DIVISION OF RECLAMATION, MINING AND SAFETY

**Re: Howard Pit #1 & #2, Permit No. M-1999-033;
Second Adequacy Review, Revision No. AM-01**

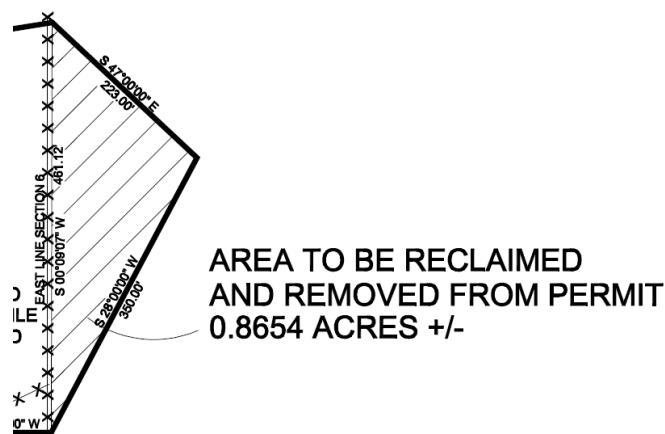
7. Division Clarification on “Area to be Reclaimed and Removed from Permit”. During the preliminary adequacy review, the Division interpreted the note pointing to the hatched triangle (see captured image below) as an action that was to take place in the future. However, upon further review, the Division noted that this area is not included in the revised legal description, nor is the area included in the revised total 8.956 permit acres. Therefore, the Division concludes the County’s intent is to remove this area from the permit as part of this amendment (AM-01) application.

For the purpose of tracking the release of permitted area, the Division requires Operators to submit an Acreage Reduction (Partial Release) request (a form is attached). As such, there are two options to proceed:

- a. Request an Acreage Reduction using the attached form. This process can proceed in parallel with the amendment process. However, this option will require an extension request to the Decision Date because notifications, and a Division inspection are required to complete the release process. This option assumes the inspection by the Division would determine the area to be releaseable, which is not guaranteed.
- b. Revise the maps and lease to include the hatched area. The Division estimates the total area to be 9.8 acres \pm allowing the site to be less than the maximum 10 acres for a 110 construction reclamation permit. The area could then be released in the future after reclamation requirements are met.
